DECISION OF THE PLANNING ADMINISTRATOR

**PARTITION TENTATIVE PLAN / CLASS 3 SITE PLAN REVIEW CASE NO.: PAR-
SPR24-13**

SUMMARY: Multi-family development of 60 units as Phase II of the Gussie Belle Commons.

IN THE MATTER OF APPROVAL OF TENTATIVE PARTITION PLAN, AND CLASS 3 SITE PLAN REVIEW, CASE NO. PAR-SPR24-13 739 23RD ST NE)))))	FINDINGS AND ORDER FEBRUARY 4, 2025
--	-----------------------	---

PARKING TREE CANOPY COVERAGE:
 PARKING LOT SF: 23,796 SF
 40% PARKING LOT SF = 9,518 SF

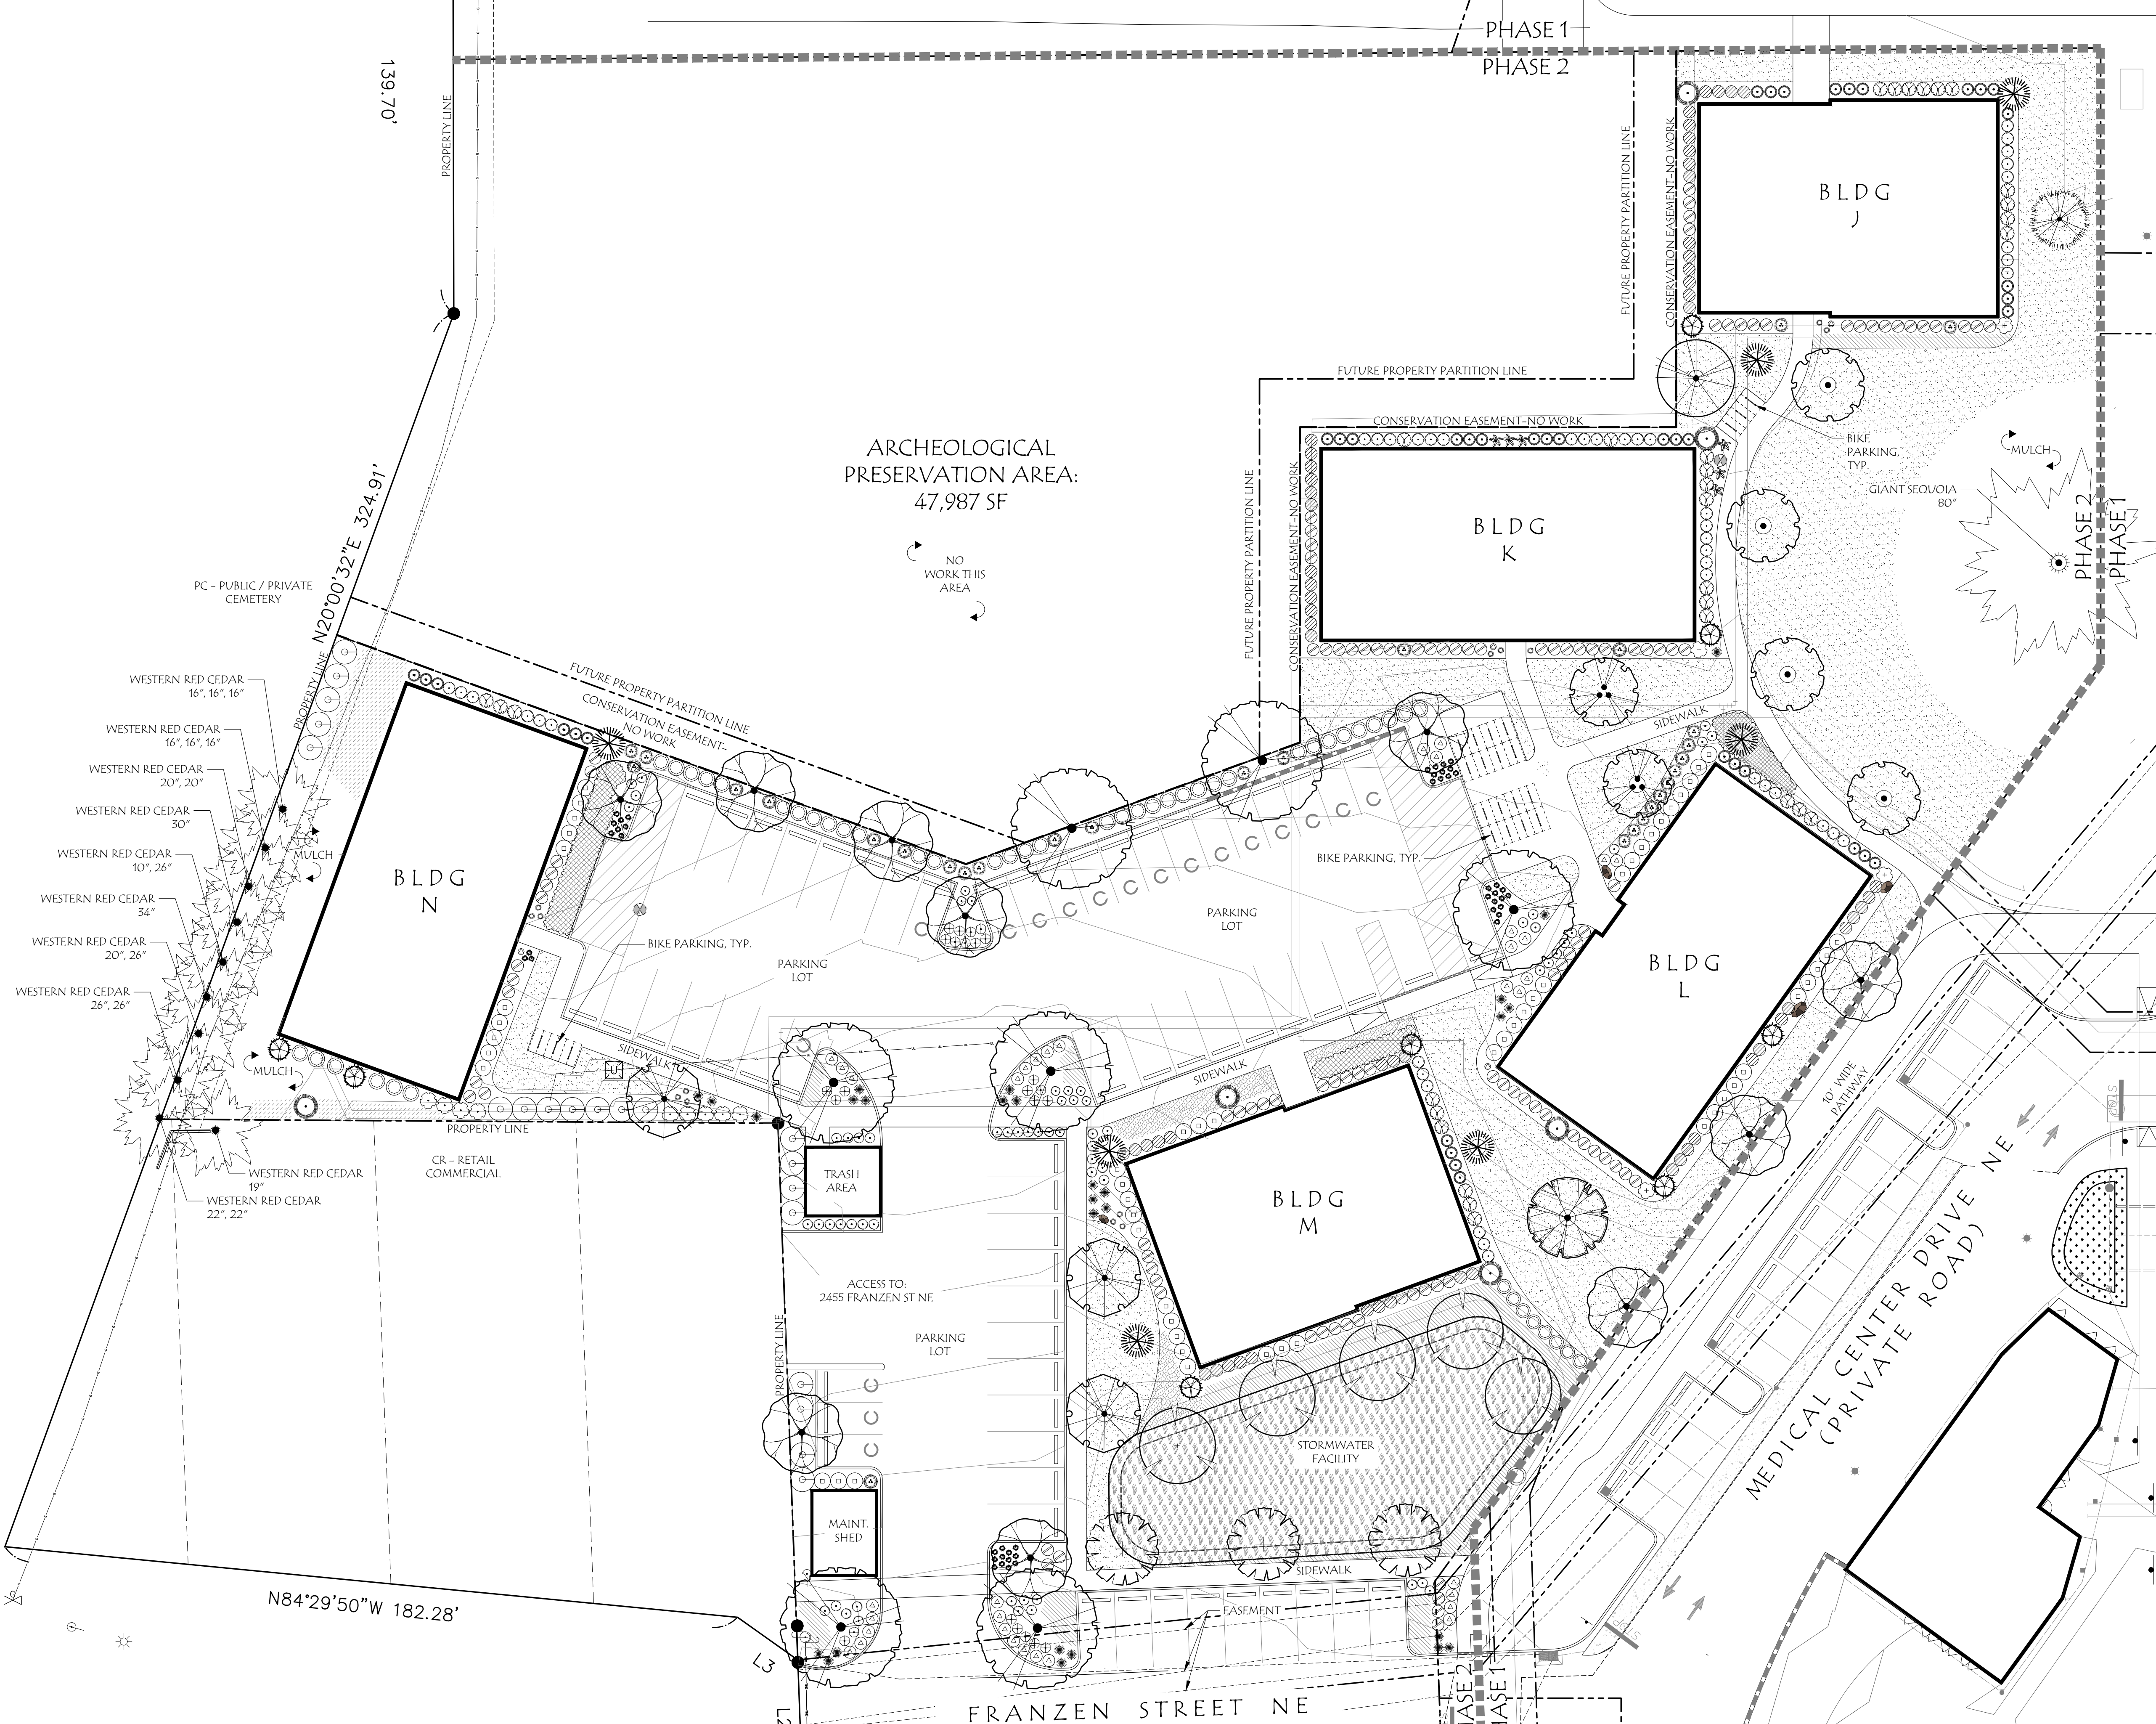
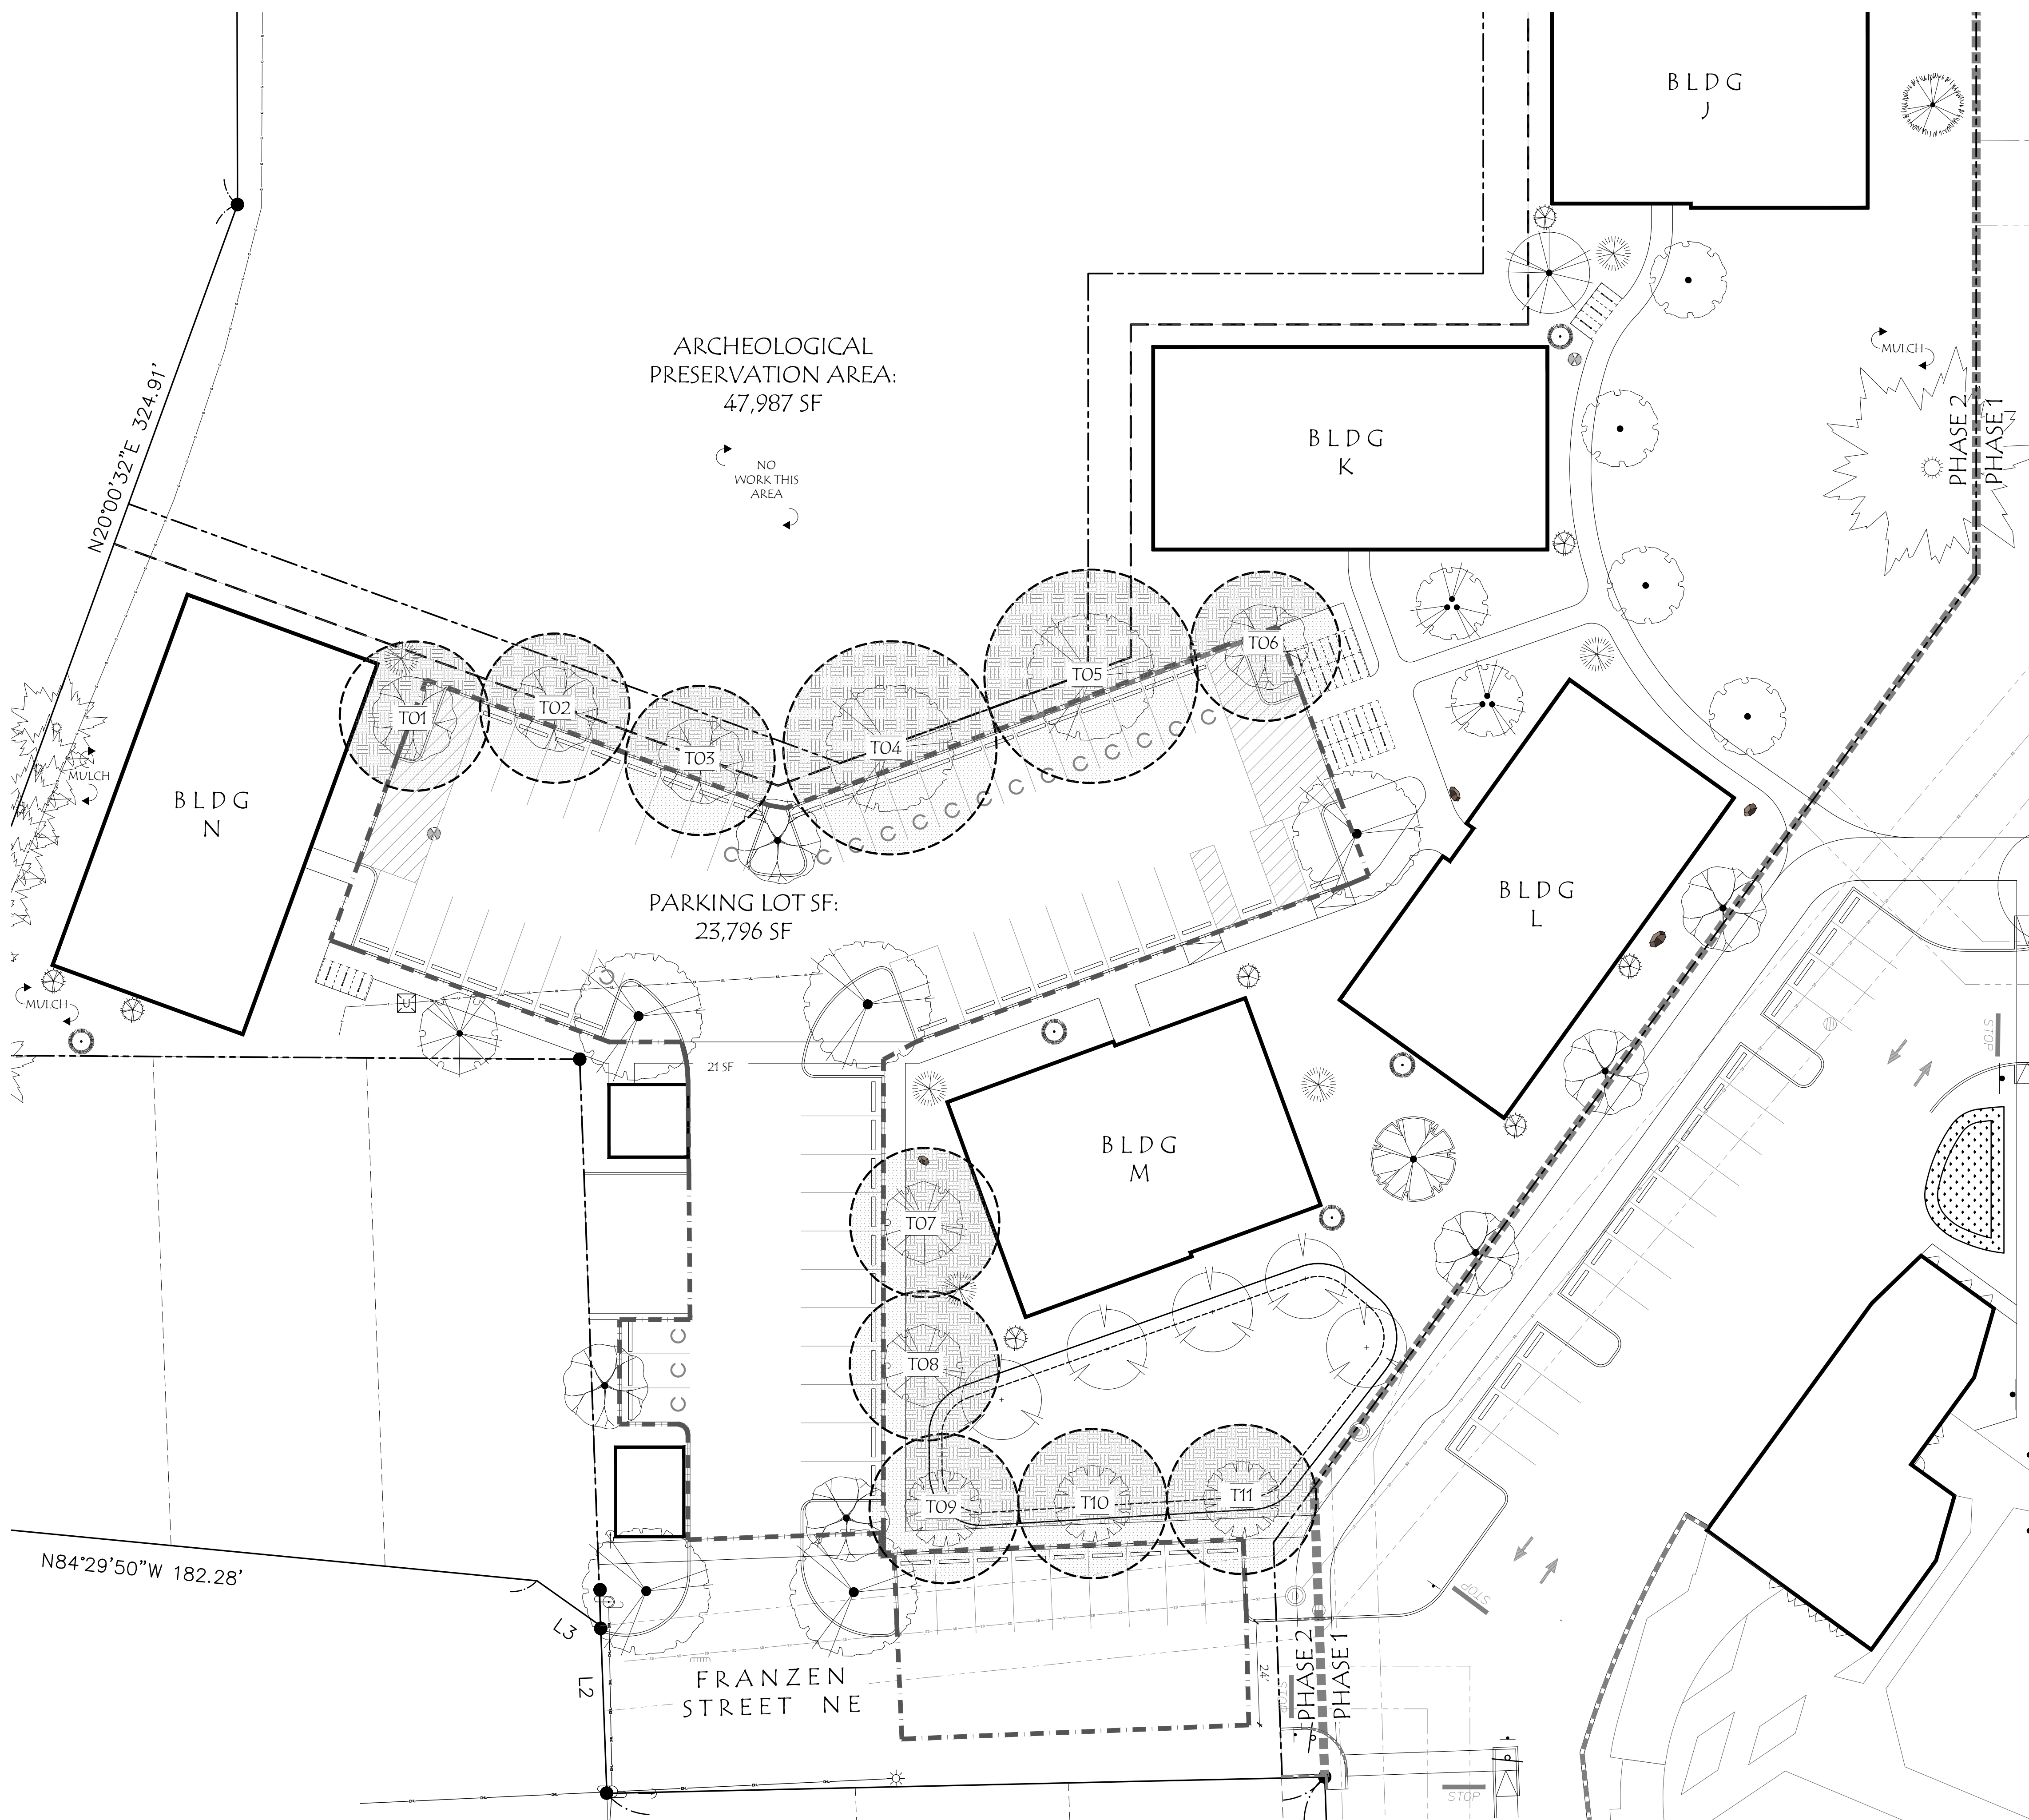
Finding: The applicant's statement and plans propose to meet the climate mitigation measures through Option C, covering at least 40 percent of the new off-street parking and vehicle use areas with the projected tree canopy area. The applicant's statement and plans indicate that the proposed surface parking area is approximately 24,170 square feet in size, requiring a minimum 9,668 square feet of tree canopy ($24,170 \times 0.4 = 9,668$). The applicant's plans indicate 12,439 square feet of total tree canopy coverage is proposed, or approximately 51 percent. This standard is met.

Finding: The development plans indicate 12,439 square feet of tree canopy coverage will be provided around the perimeter of the off-street parking area, equivalent to approximately 51 percent of the off-street surface parking and vehicle use areas, meeting Option B for this requirement. This standard is met.

Finding: The development plans indicate 11 trees will be planted to meet the CFEC standards, using three types from Table 806-7; two of which have an expected 15-year tree canopy diameter of 50 feet, and nine with an expected 15-year tree canopy diameter of 35 feet. All except one tree (no. 8) near the southern parking area along Franzen Street NE will be planted within ten feet of the parking area. The trees in this area are behind a pedestrian sidewalk, and may need to be moved slightly closer to ensure the standard is met; therefore, the following conditions applies:

Condition 11: Prior to approval of landscape plans for the proposed development, the landscape plan shall be updated to ensure all trees planted to meet the climate mitigation requirements are located within ten feet of the parking area, and demonstrate compliance with all tree canopy standards in SRC 806.035(n)(3), including a continuous canopy for any revisions made.
